Re: **Windhaven Estates Re-Plat Review**

Re: **Windhaven Estates Preliminary Civil Construction Plans - Review #1**  
Dear Ms. Hammonds,

Halff Associates, Inc. was requested by the City of Sanger to review the Preliminary Civil Construction Plans for the Windhaven Estates. This submittal was prepared by Homeyer Engineering, Inc and was received on November 4<sup>th</sup>, 2024.

PRELIMINARY CIVIL CONSTRUCTION PLANS  
for  
Windhaven Estates  
19.50 Acres  
City of Sanger  
Denton County, Texas  
October 2024

**REPLAT**  
**WINDHAVEN ESTATES**  
 LOTS 1 - 30 & 31X, BLOCK A  
 19.51 ACRES

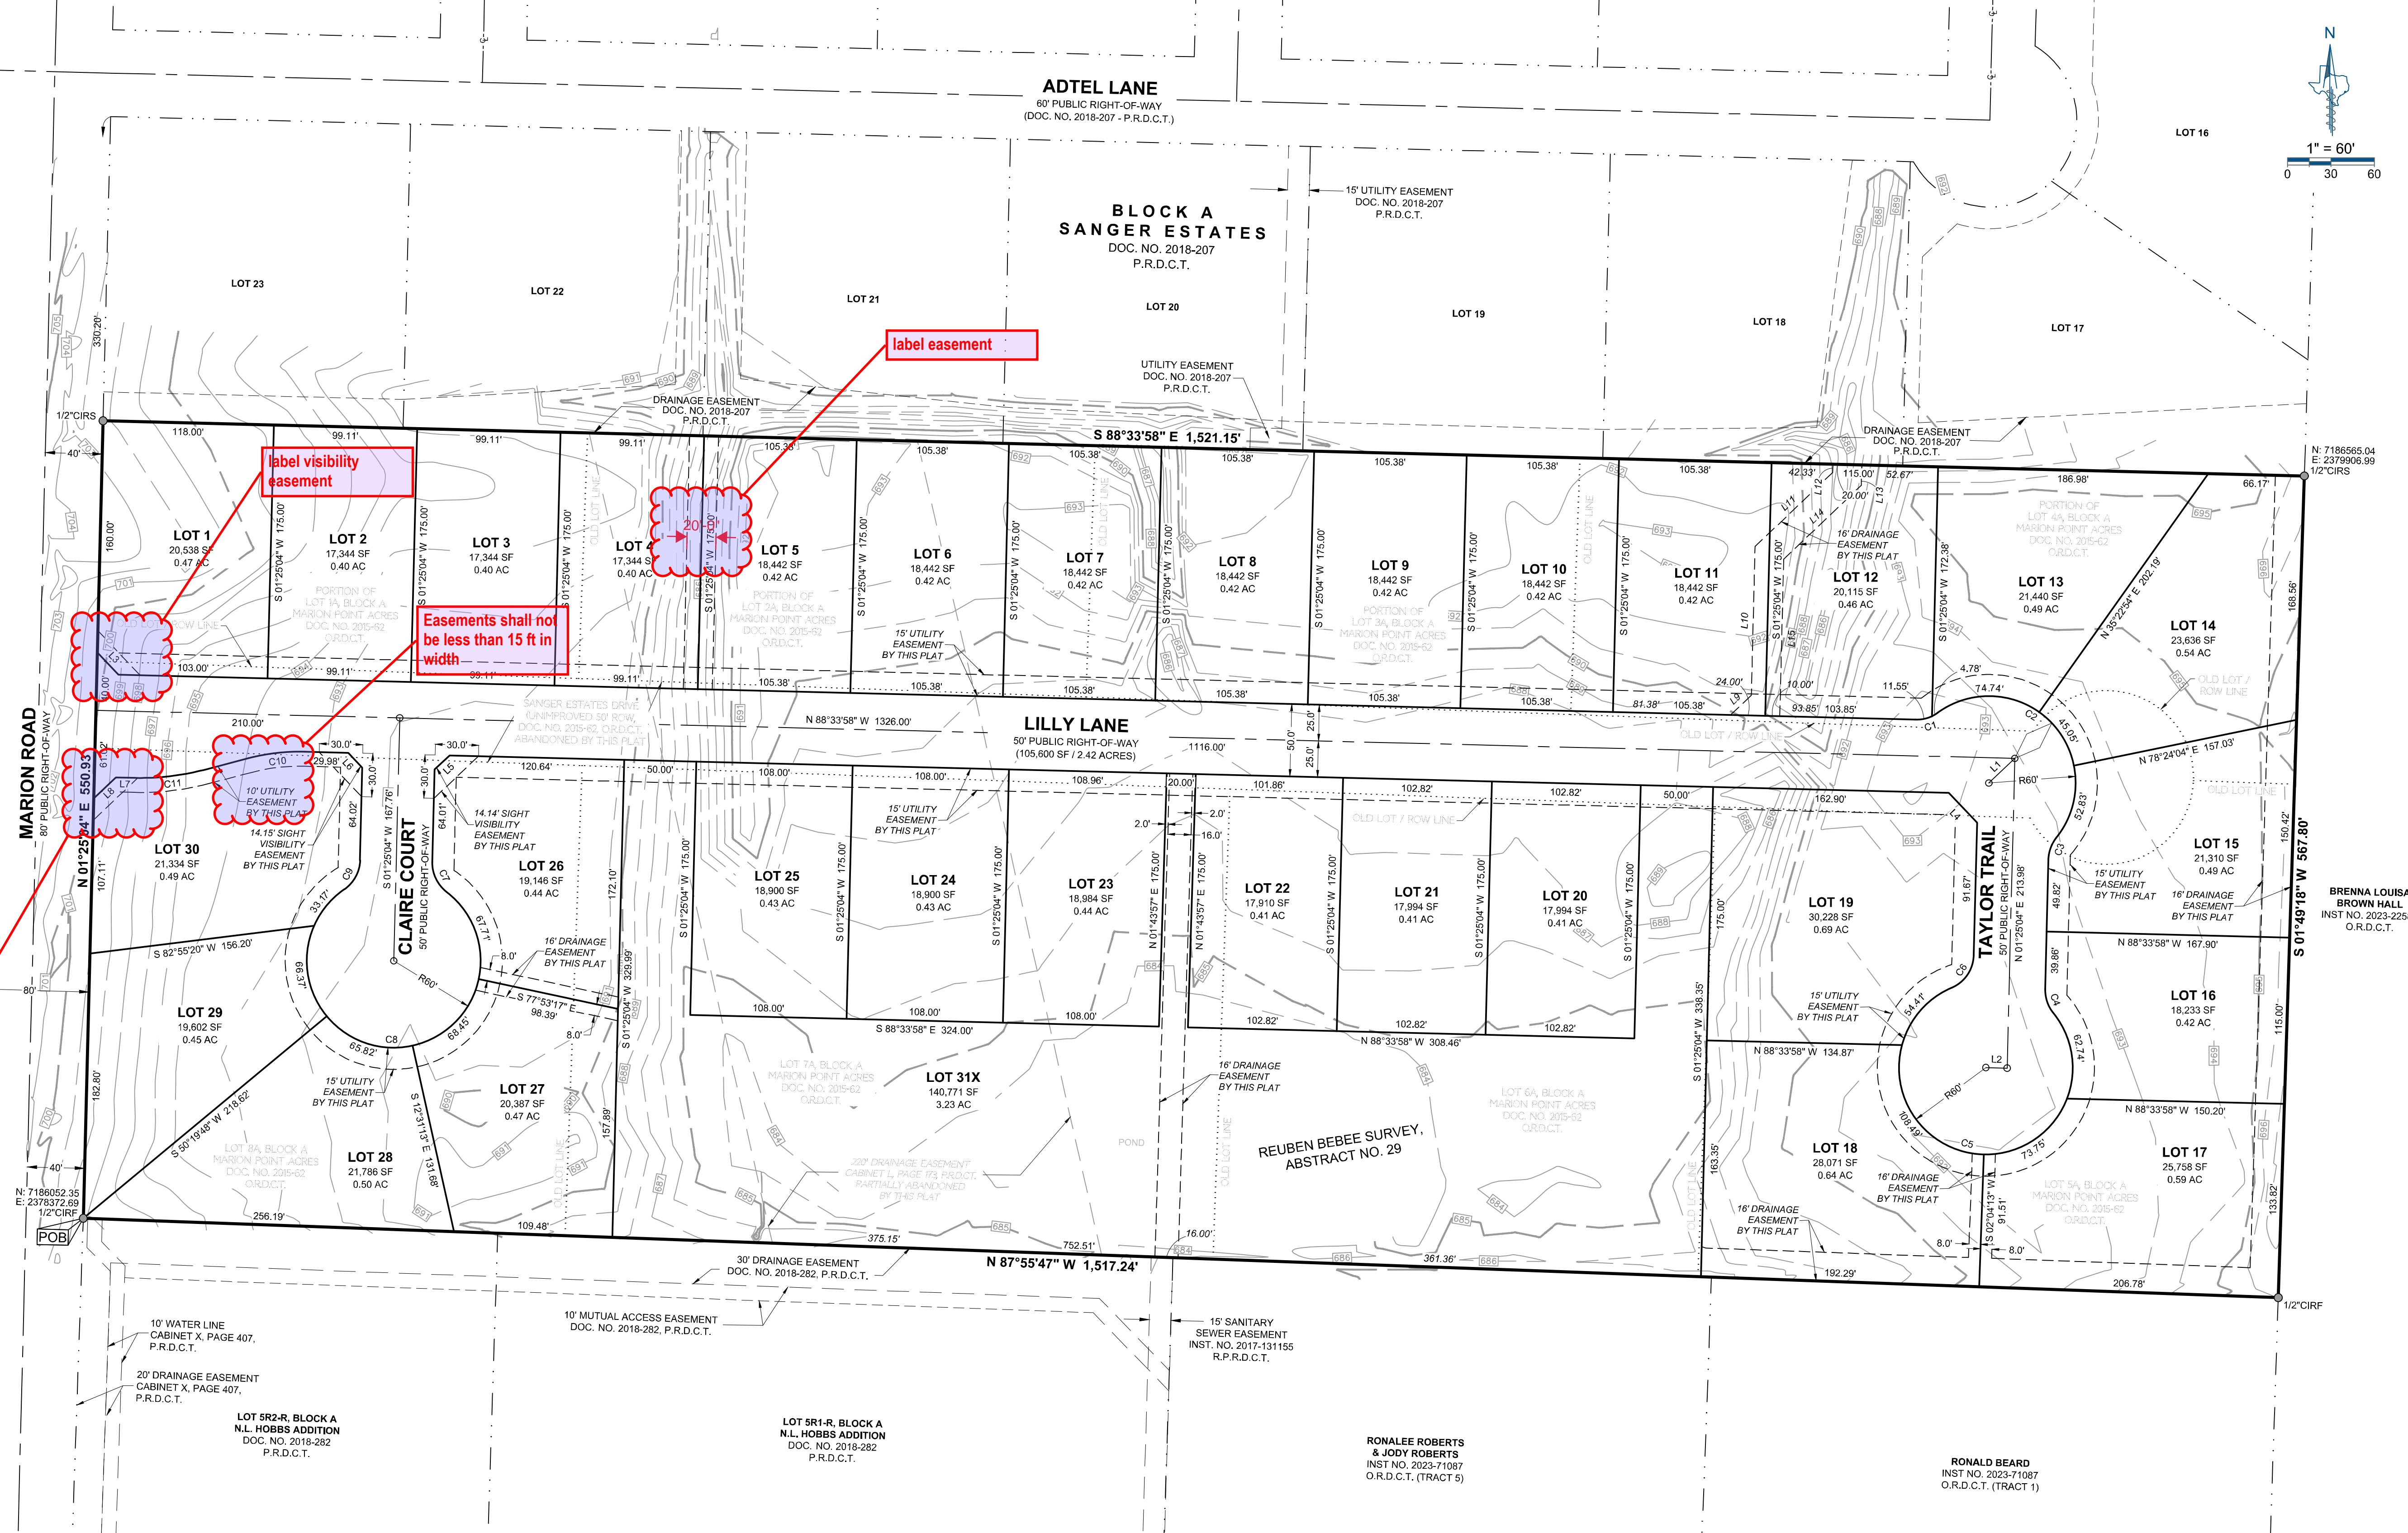
label visibility easement

label visibility easement

label easement

Easements shall not be less than 15 ft in width

GRADING PLAN  
 WEST

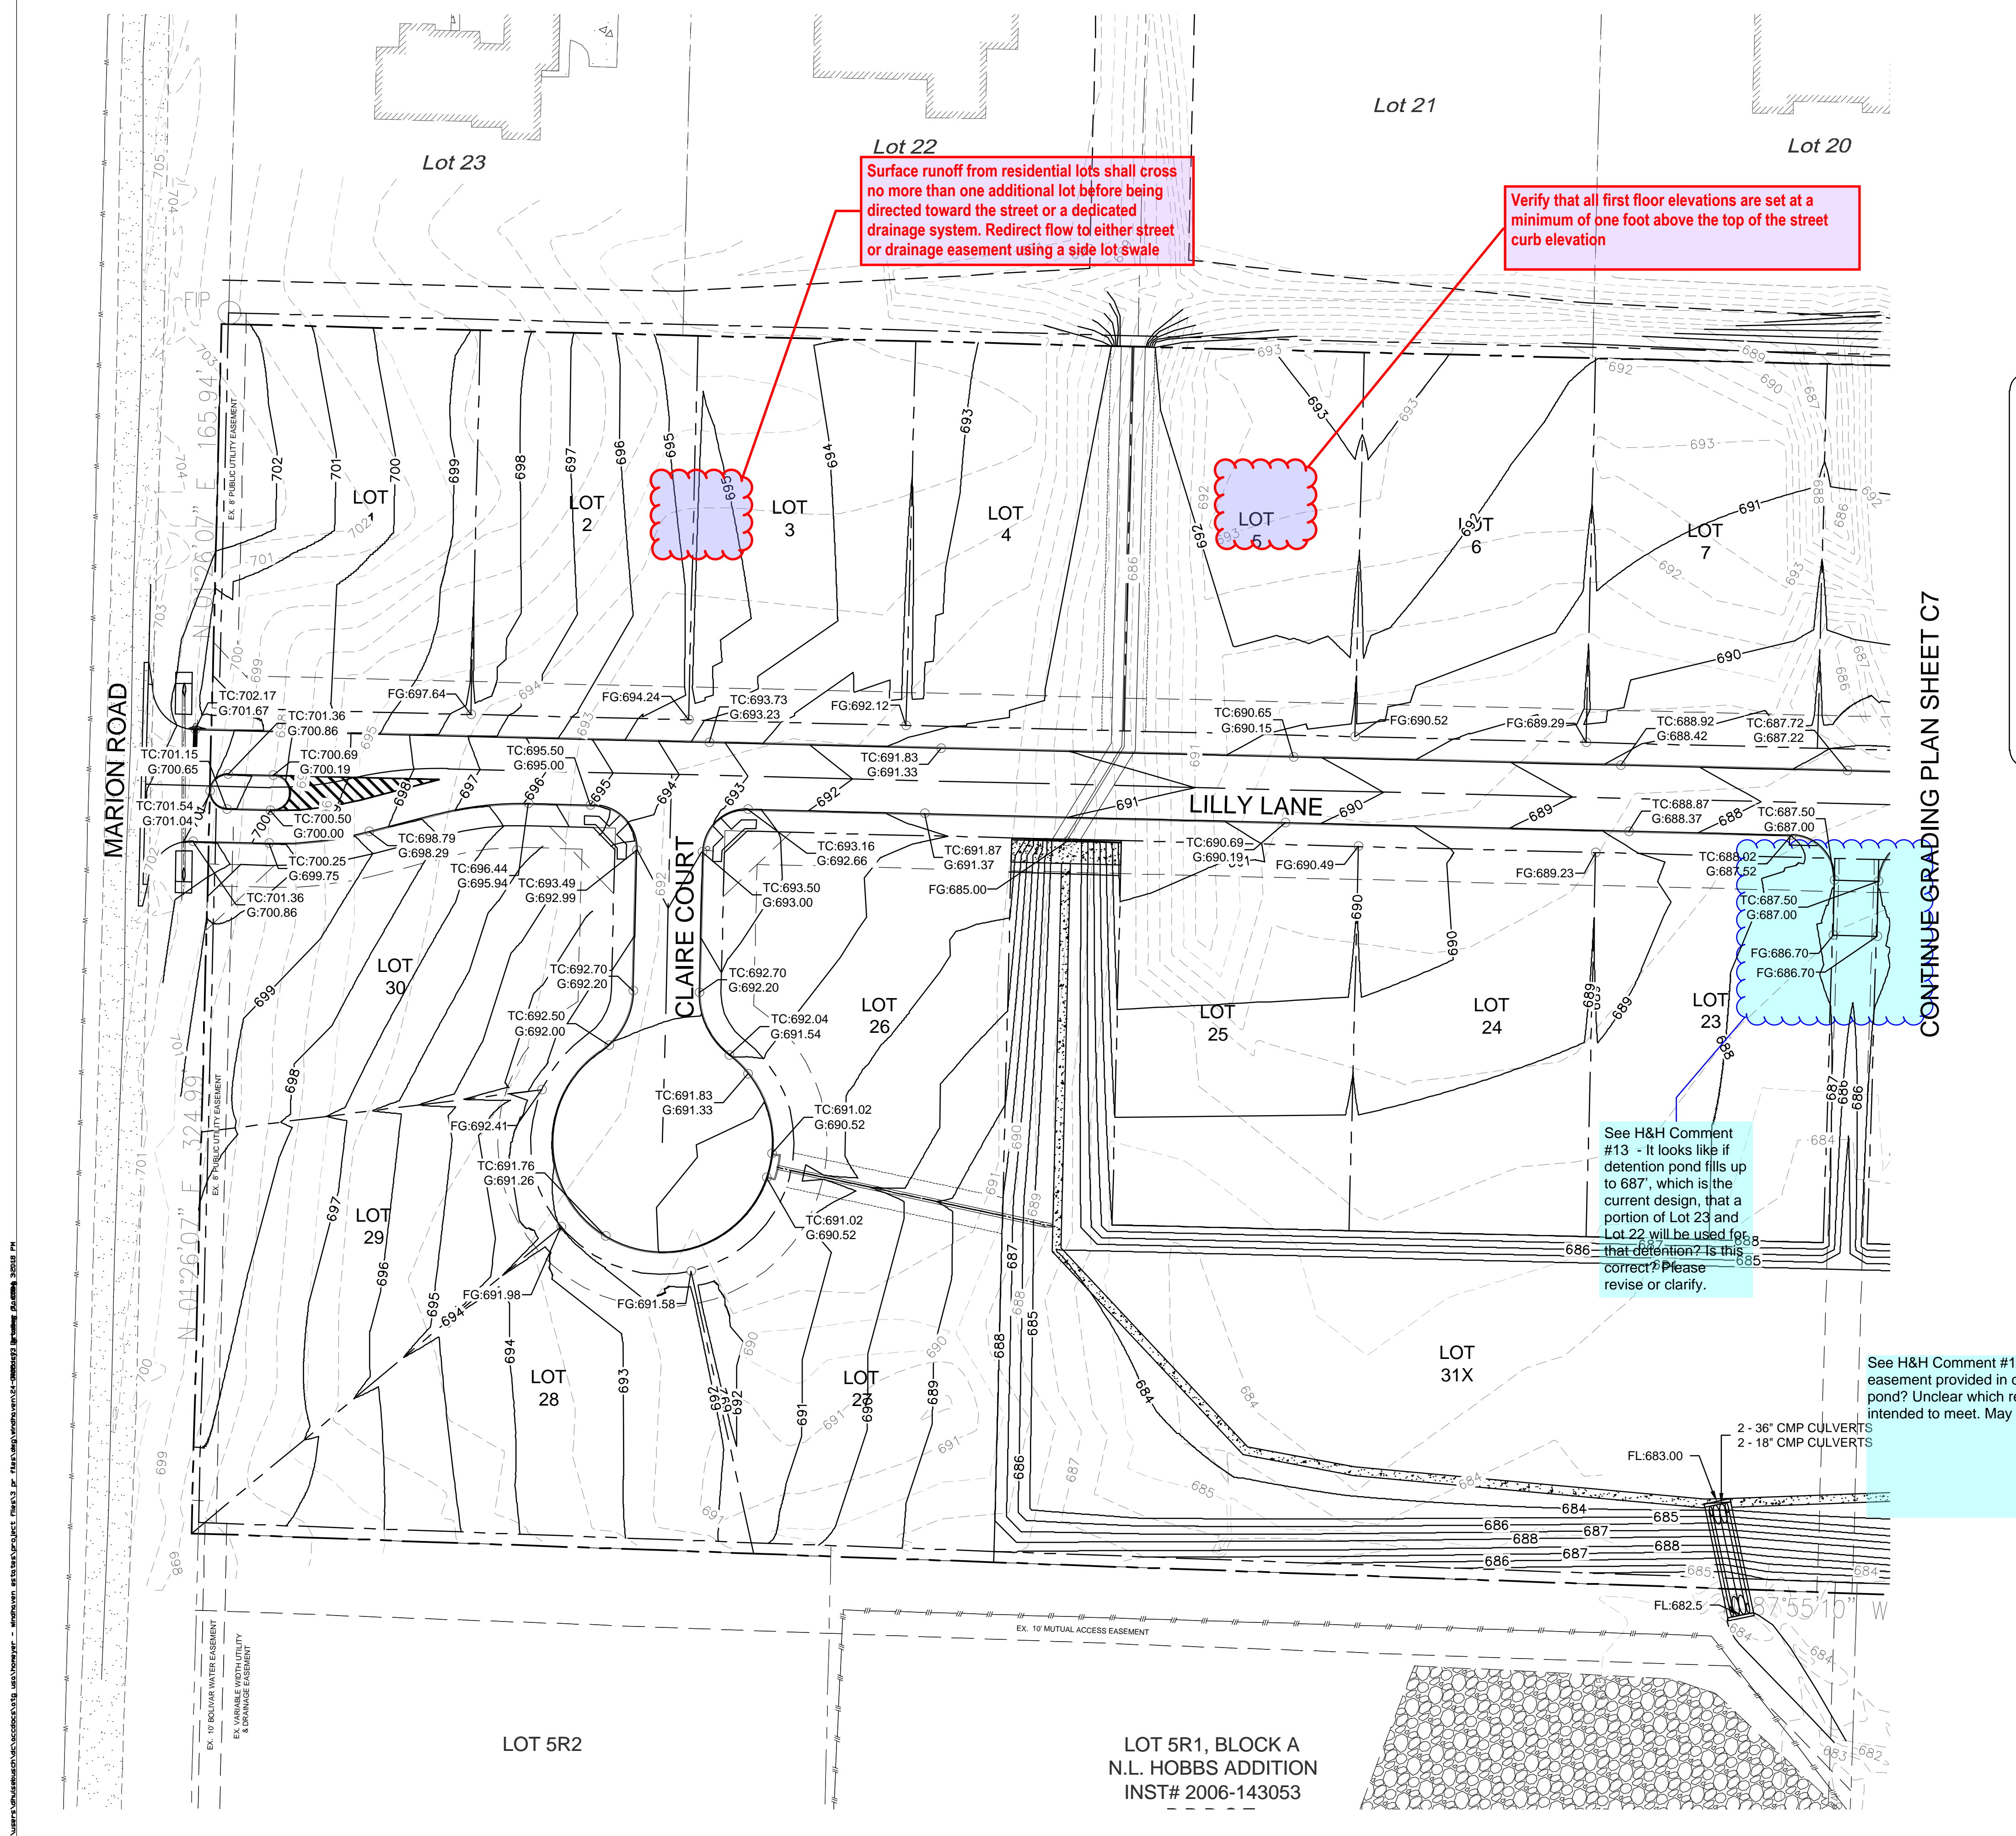
Verify that all first floor elevations are set at a minimum of one foot above the top of the street curb elevation

See H&H Comment #13 - It looks like if detention pond fills up to 687', which is the current design, that a portion of Lot 23 and Lot 22 will be used for that detention? Is this correct? Please revise or clarify.

See H&H Comment #14 - Why was easement provided in center of detention pond? Unclear which regulation this is intended to meet. May not be necessary.

EXISTING DRAINAGE AREA MAP

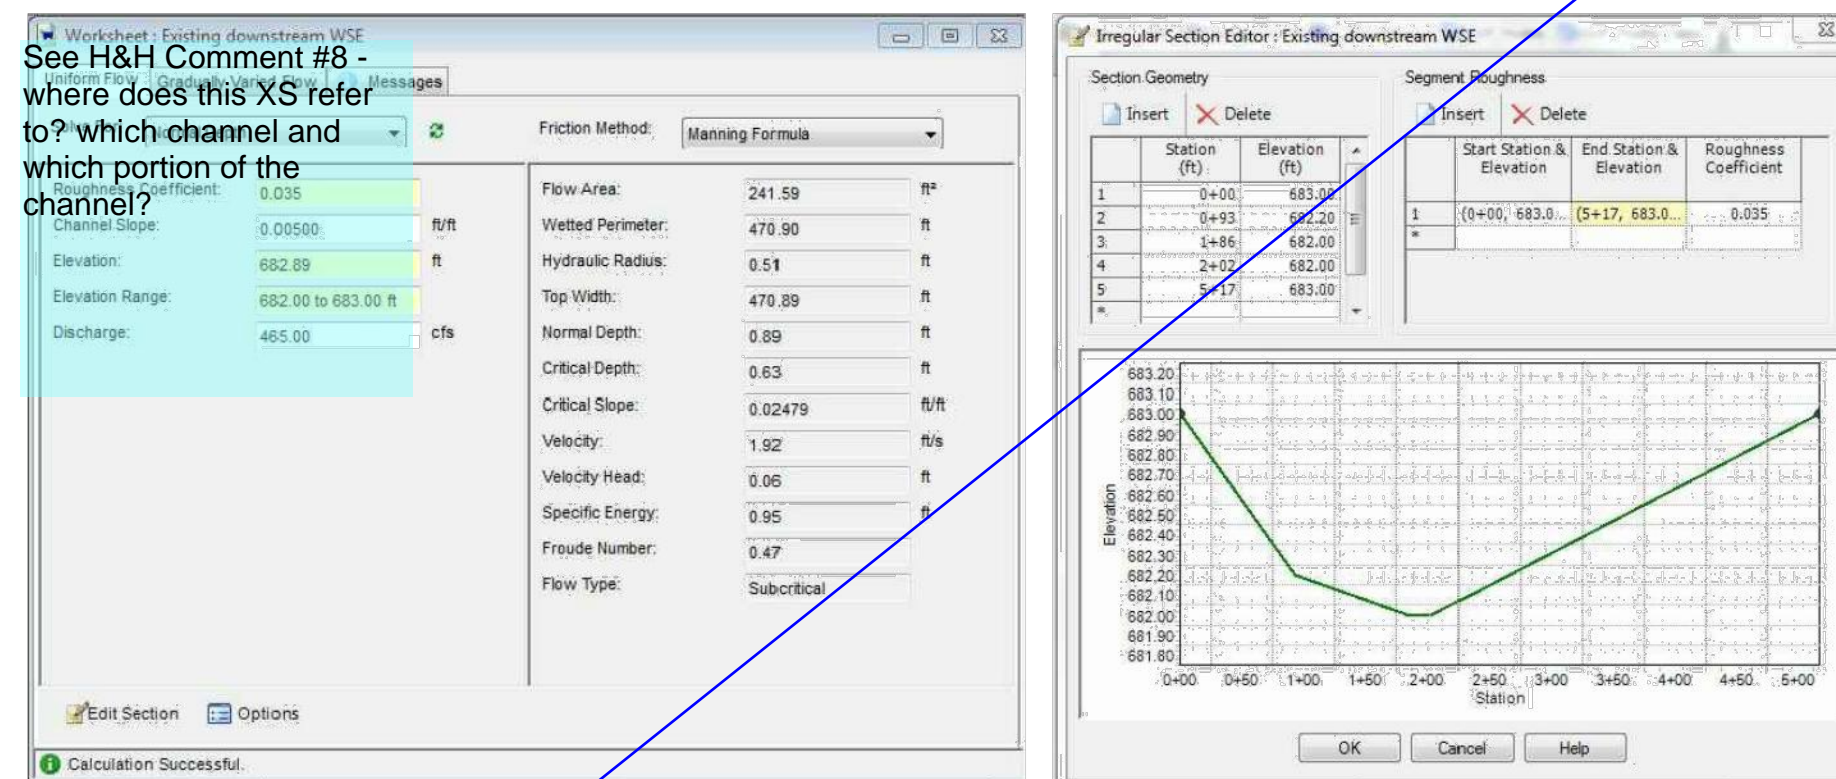
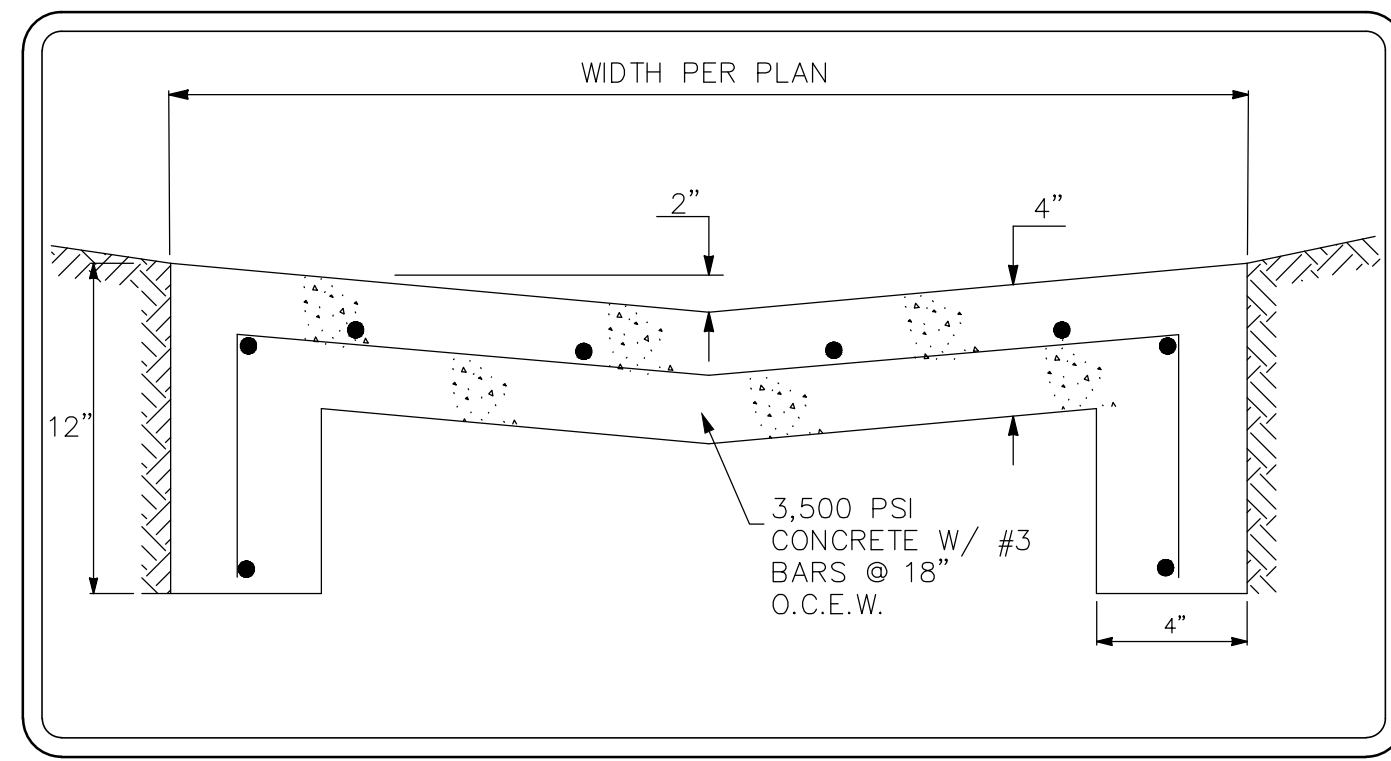
See H&H Comment #4 - Existing Drainage Area map does not appear to account for offsite flows coming from north of site. If additional drainage area north of site drains to site, this will affect detention pond sizing. Please revise.

See H&H Comment #5 - Please provide drainage calculations in proposed drainage area map similar to existing drainage area map.

See H&H comment #4, The Q100 entering your detention pond (554 cfs) also does not appear to be equivalent to the total flow you've calculated in your existing drainage area calculations (271 cfs). Is there 280 cfs offsite for which calculations need to be provided?
